PROFILE, ALIGNMENT AND GRADE OF
SANITARY SEWERS PAGE 1
 TO BE CONSTRUCTED IN
TRACT NO. 28176
 AND IN SANITARY SEWER R/W

PRIVATE CONTRACT NO. 8053

W.S. 30
 3 SHEETS, 6 PAGES

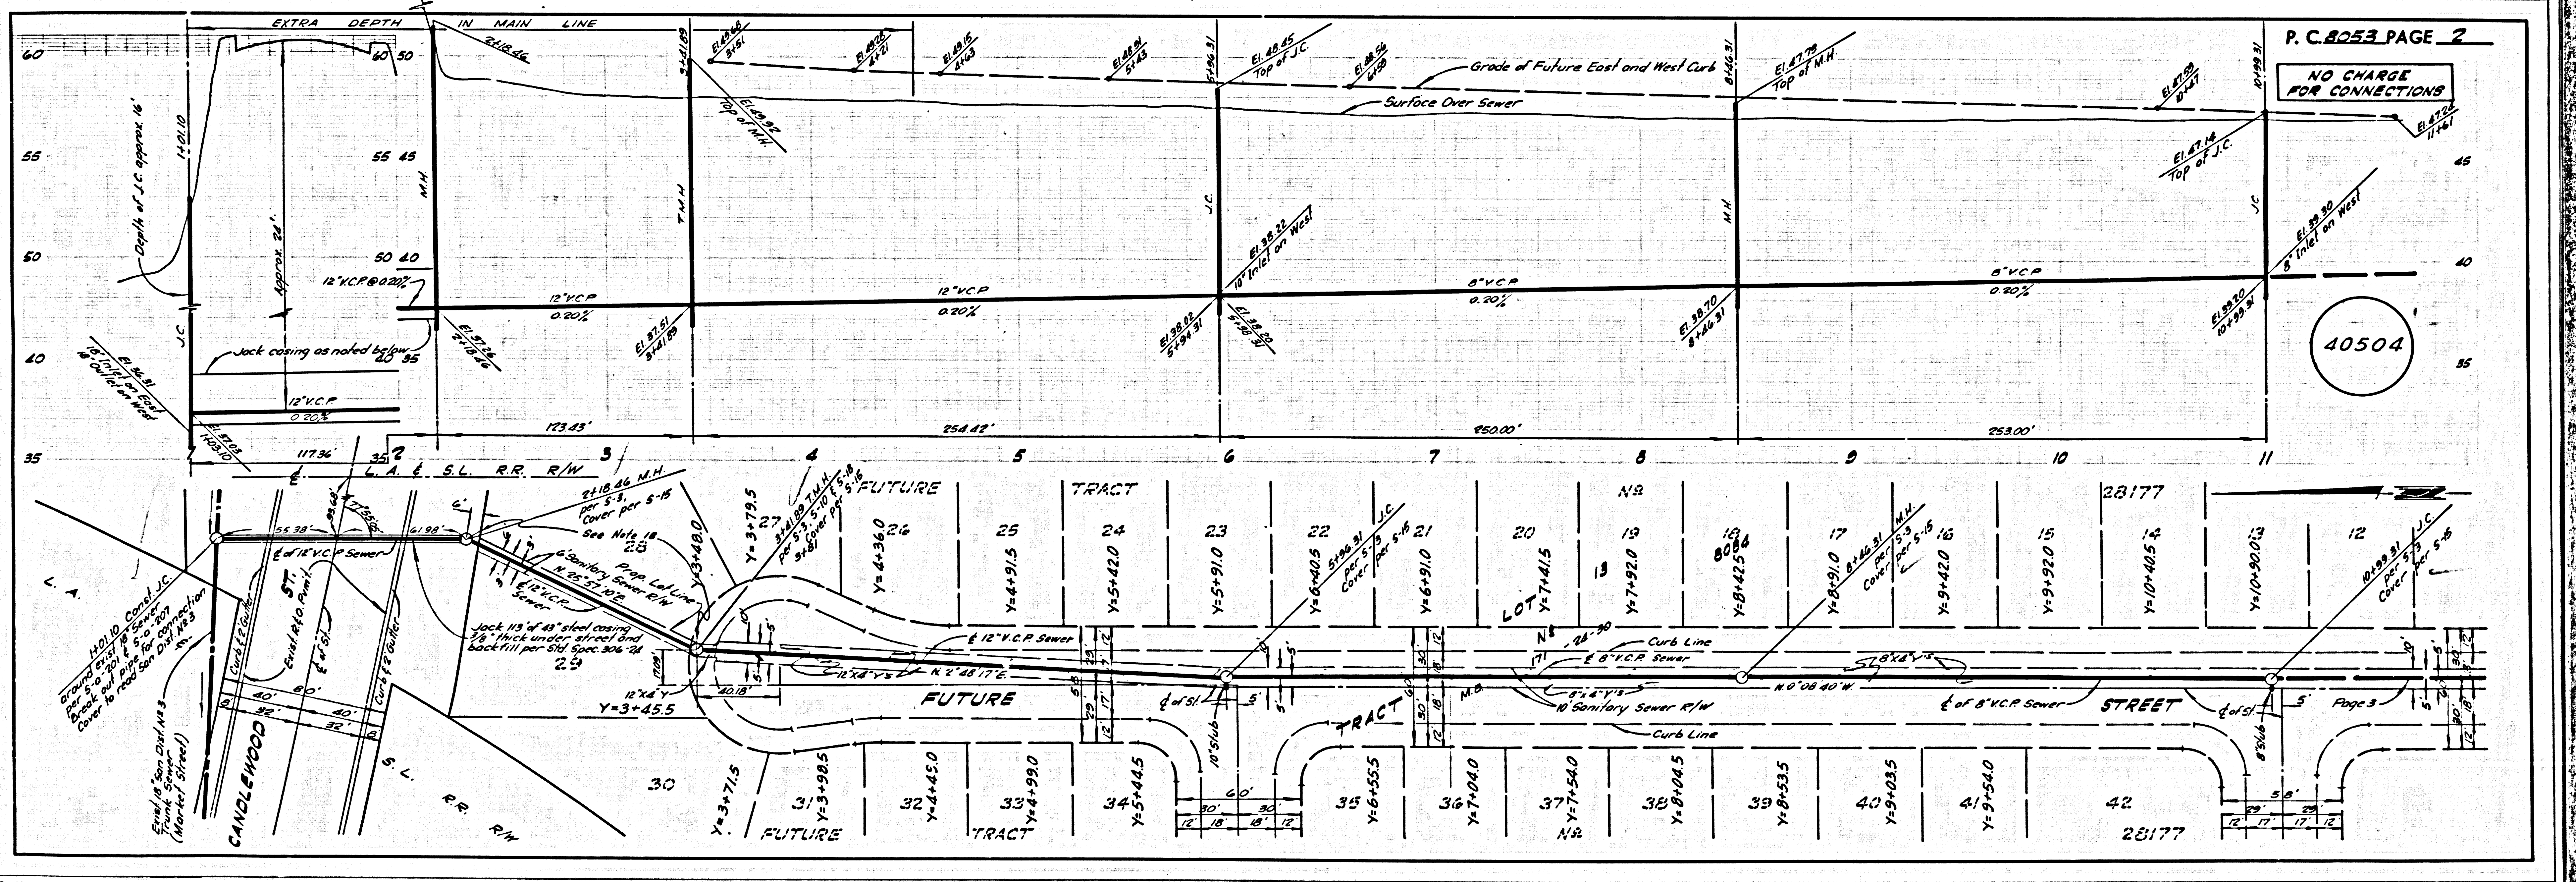
REVISION NO. 2
 Changed 8" V.C.P. to 12" V.C.P. 5'
 and 8" S.P.C. to 12" S.P.C. 12/4/68
 APPROVED: *Quail E. McColl*
 Office of the County Engineer

REVISION NO. 3 Nov 26, 1968
 Construct five (5) house laterals (each being 25' in length) to serve lots 1-5 of proposed tract N/A 29395. These laterals to be constructed of 8" V.C.P. per foot and are to be encased per S-23 as shown on page 3.

REVISION NO. 1 July 8, 1968
 1. Changed 8" V.C.P. manhole to 12" V.C.P. from Sta. 1+02.10 to Sta. 2+04.21 on Page 2.
 2. Changed all 38" steel casing to 48" on page 2.
 3. Changed 8" stub of Sta. 5+16.31 to 10" stub on Page 2.
 4. Changed 8" V.C.P. manhole to 8" C.I.P. from Sta. 19+30.31 to Sta. 19+60.31 on Page 3.
 5. Added 8" stub to east side of J.C. of Sta. 19+45.31 on Page 3.
